PEAVEY ELECTRONICS INC.			
TITLE: XR1212 Amplifier			
DRAWN: jdb	DATED: 10/08/07	CODE:	REV: 02
CHECKED:	DATED:	SIZE:	DRAWING NO:
QUALITY CONTROL:	DATED:	SCALE:	SHEET: 1 OF 1
RELEASED:	DATED:

PEAVEY ELECTRONICS INC.			
TITLE: Power Supply			
DRAWN: F.D.B.	DATED:	CODE:	REV:
CHECKED:	DATED:	SIZE: D	DRAWING NO.:
QUALITY CONTROL:	DATED:	SCALE:	SHEET: 2 OF 2
RELEASED:	DATED:

C

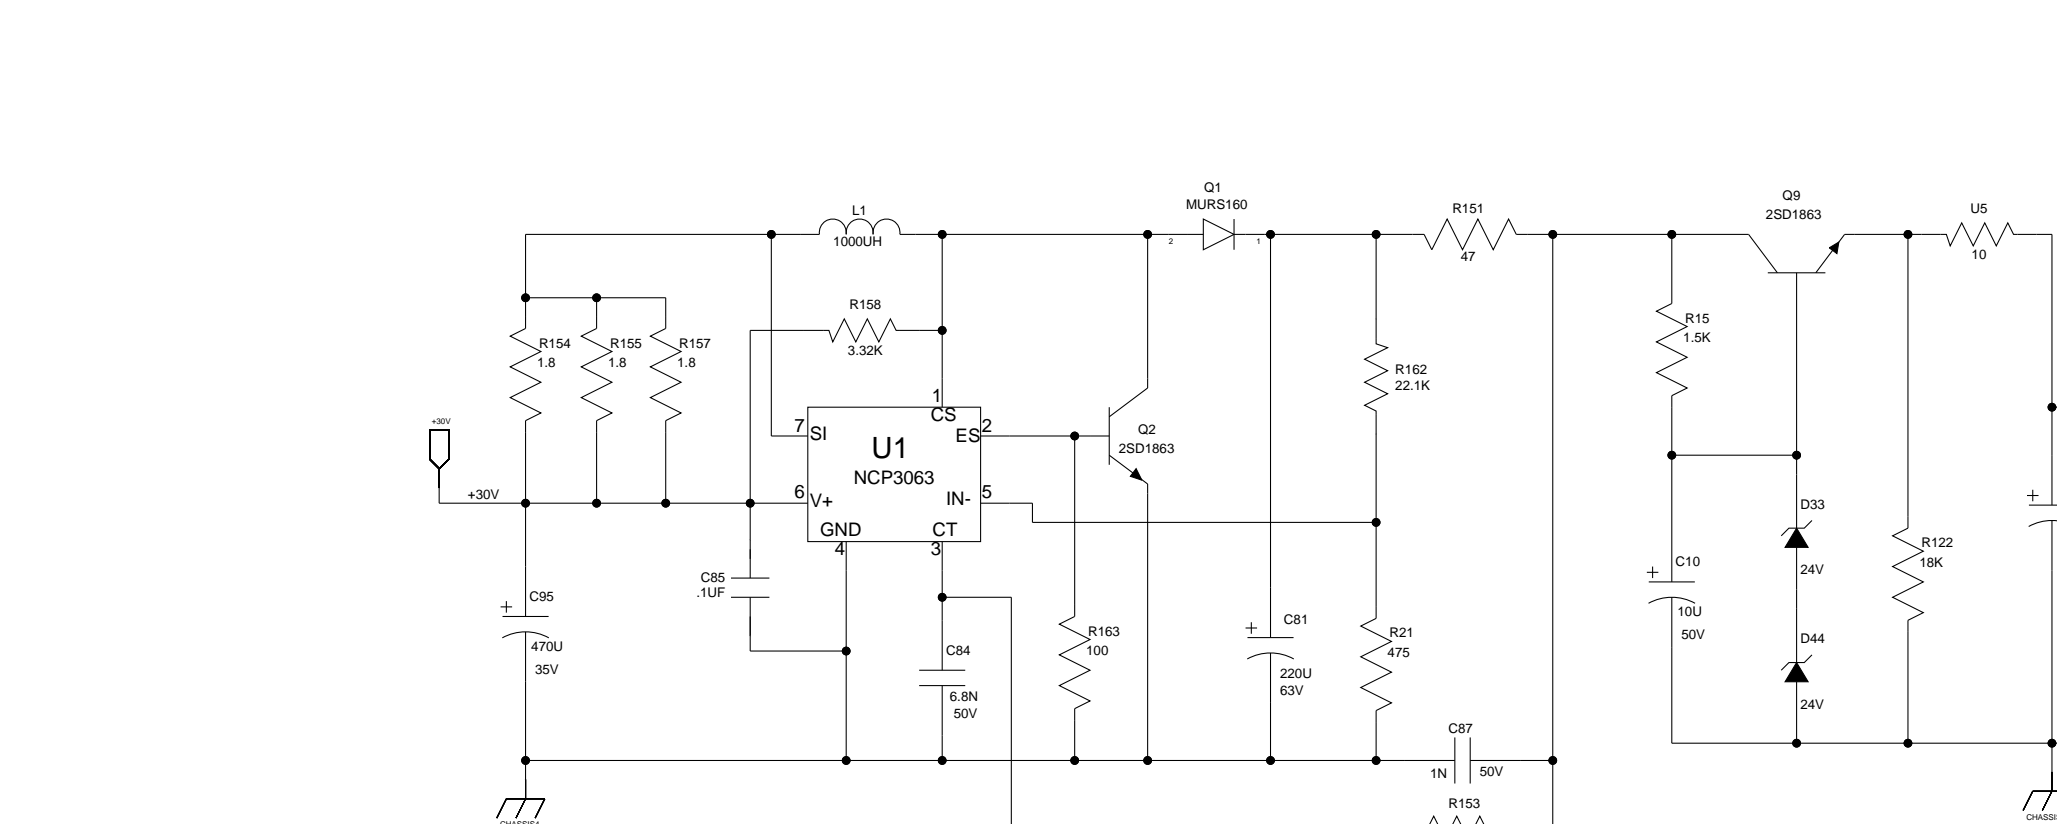
DELETE Q102, R121, R122 FOR MIXER VERSION  
DELETE Q100, R131, R130 FOR MIXER VERSION  
DELETE Q202, R221, R222 FOR MIXER VERSION  
DELETE Q200, R231, R230 FOR MIXER VERSION  
9/10/07 CHANGE Rx42 & Rx44 TO 1K FOR 4 OHM LIMIT FOR MIXER VERSION

8/8/07 ADDED 47.5K ACROSS Cx29  
9/19/07 DELETED SNUBBER PARTS R61, R66, R78, R79, R80, C77, C79, C21  
9/4/07 CHANGED Rx14 CONNECTION  
6/4/07 CORRECTED R73 TRACK ERROR  
6/4/07 CORRECTED BRIDGE ROUTING  
7/25/07 DELETED Cx14  
9/4/07 CHANGED J4 & J7  
8/7/07 CHANGED L9 TO 18.5uH 30500891  
8/7/07 CHANGED ICx04 TO LM358  
9/13/07 CHANGED R99 FROM 13.3KTO 12.1K 30200376  
9/13/07 CHANGED R3, R71 R99 FROM 1206 TO 0805 30200376  
9/12/07 PENDING .... CHANGE LCI INDUCTORS TO 8mH  
9/12/07 CHANGED Rx33 & Rx34 TO FROM 22 TO 10 OHMS 30200239  
6/12/07 CHANGED C22 FROM .47uF 30300253 TO .068uF  
9/12/07 CHANGE R243 TO 4.99K 30200173  
9/12/07 ADDED Rx56 & Rx60 10 OHMS 30200239 IN SERIES WITH Rx33 & Rx34  
8/7/07 CHANGED Rx20 FROM 221 TO 200 30200373  
8/5/07 CHANGED Rx42 & Rx44 FROM 4.99K TO 2K 30200204  
9/4/07 ADDED TEMP AND DC LEDS + CIRCUITRY. DELETED PILOT  
6/12/07 CHANGED C48 FROM 470pf 30300090 TO 270pF.

8/15/07 CHANGED Cx05 FROM 150pF 30300065 TO 100pF 500V 1210 2%  
8/24/07 CHANGED VALUE OF R80, R79, R78, R66, R61 FROM 10R TO 22R  
9/4/07 CHANGED Rx50 & Rx58 FROM 24.3K 0.1% TO 16K 1%  
9/13/07 CHANGED R1048 ROM 1.21KTO 6.19K  
6/4/07 CHANGED Rx47 FROM 1.5K 30200284 TO 2.67K 30200470  
8/17/07 CHANGED Cx01, Cx03, Cx07 TO 1%  
8/14/07 DELETED RX86 (DC PROTECT GATE RESISTORS)  
8/8/07 CHANGE GATE RESISTORS TO 6.8R  
9/10/07 FOR 24V FAN, ADD Z7. BYPASS FOR 12V FAN.  
8/21/07 C26 CHANGED FROM 220uF TO 1000uF 30300082  
9/13/07 CHANGED R98 FROM 16KTO 22.1K 30200256  
9/14/07 BYPASS R82 AND CHANGE R20 TO 4.99K 30200173  
8/6/07 CHANGED R90 FROM 6.81K 30200328 TO 6.19K  
8/6/07 CHANGED R97 FROM 17.4K 30200428 TO 15.8K  
8/7/07 ADDED NEGATIVE TO GROUND ANTI SPIKE DIODE  
8/1/07 CHANGED RED PROTECT LEDS TO GREEN  
8/6/07 CHANGED Rx04 FROM 221 30200183 TO 1.5K 30200284  
7/31/07 ADDED Cx10 1nF 30300174  
9/14/07 CHANGED R42 FROM 2.49K TO 2.21K 30200236

9/14/07 MOVED BREAKER TO LINE SIDE  
9/14/07 FOR MIXER, CHANGE R82 TO 200 OHMS 30200373  
9/14/07 ADDED Q1, Q2, R1012, R1013, D38, AND D42  
9/14/07 CHANGED CONNECTION TO Cx29  
9/17/07 RENAMED C22 TO C82 AND ADDED C83  
9/17/07 DELETED R4  
9/17/07 CHANGED R43 TO 2.67K 30200413  
9/17/07 ADDED C22, D49, D50, D51, D52  
9/17/07 CHANGED OC1 & OC2  
9/21/07 CHANGED Rx04 to 3.48K  
9/21/07 Deleted VRx00  
9/24/07 Changed R1009 from 10K to 100K  
9/24/07 Changed R1008 from 2.21K to 10K  
9/24/07 Deleted Q9, R143, R243, C81  
9/24/07 Changed R23 to 100K  
9/24/07 Added C21 & D32  
9/26/07 Changed Rx21 and Clip LED connection  
9/26/07 Changed Rx31 and Active LED connection  
9/28/07 Replaced R1 with R1056 - R1069
